Addendum #1 - March 11, 2010

PROJECT: JEFFERSON PARISH SHERIFF'S OFFICE
4th DISTRICT STATION
6228 AIRLINE DRIVE
METAIRIE, LA 70003

PROJECT NO.: SA # 51122.03

FROM: SIZELER THOMPSON BROWN ARCHITECTS
PROJECT DESIGN GROUP, LLC
300 Lafayette Mall, Suite 200
New Orleans, Louisiana 70130
(504) 523-6472 (504) 529-1181f

ATTACHMENT_#3

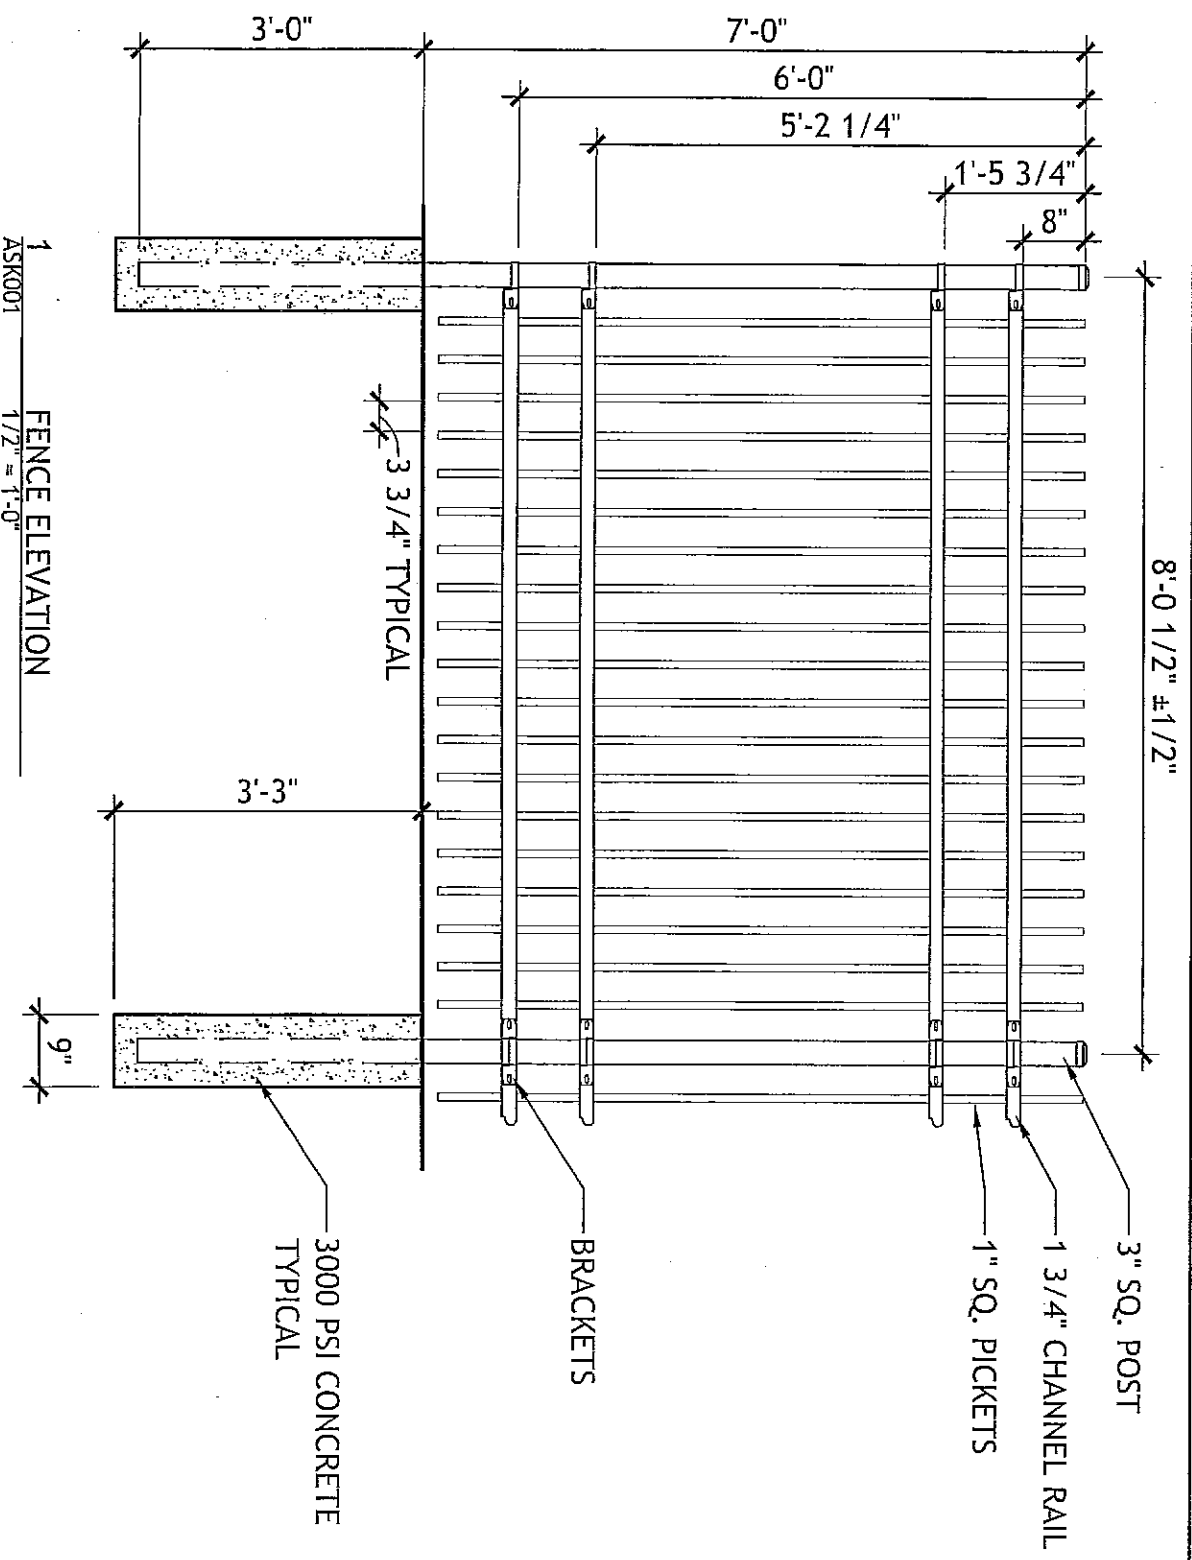
5. See Attachment #3 included in this Addendum #1 for a clarification drawing for the exterior perimeter security fence. See also item #3 above.

1  **MECHANICAL PLATFORM FOUNDATION**
 SKS-1 3/16"=1'-0" REVISION TO PLAN 6/S102.1

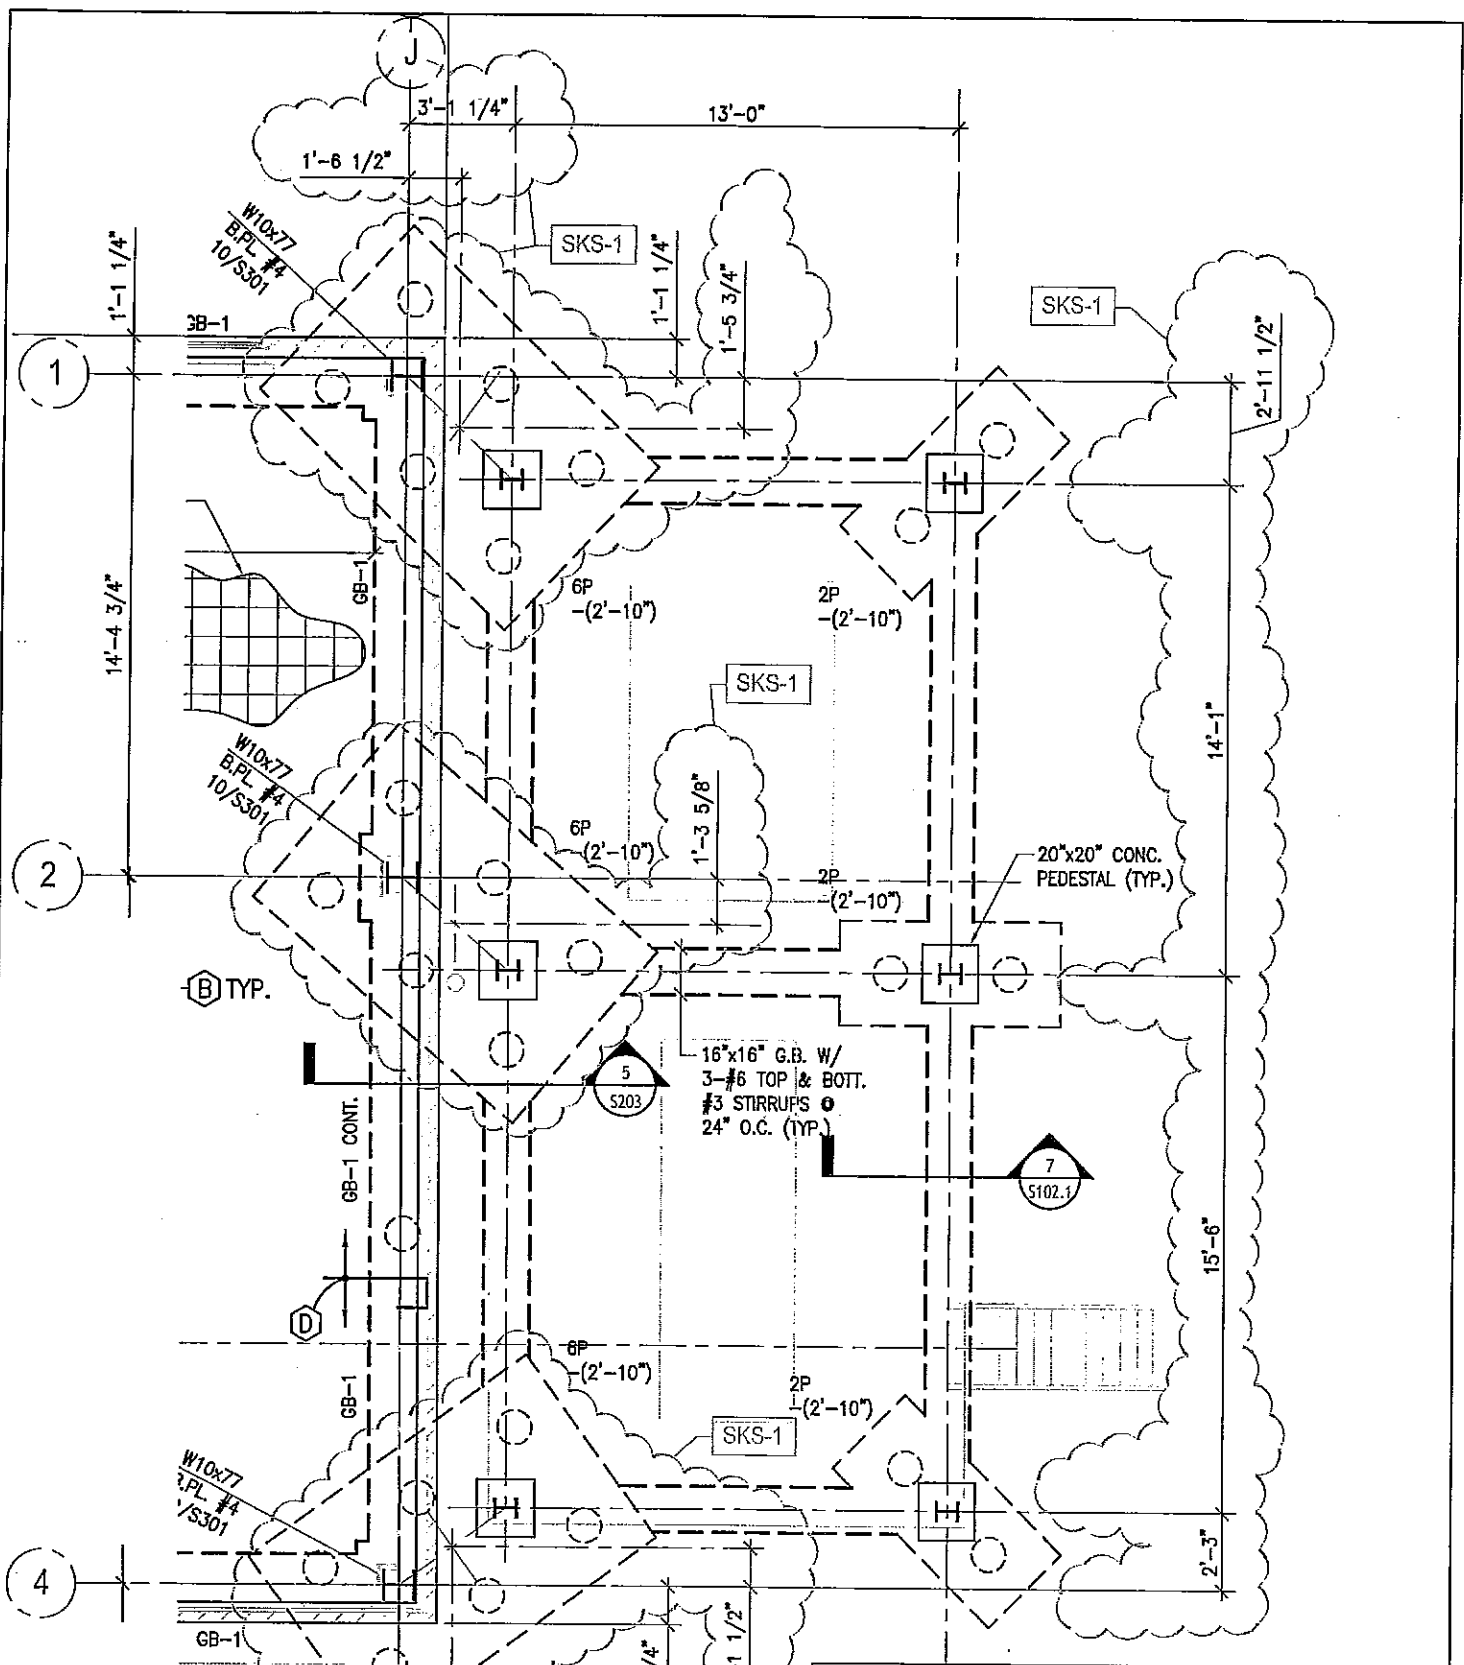
6. See Attachment #4, (SKS-1) included in this Addendum #1 for a clarification drawing of detail #6 on sheet S102.1.
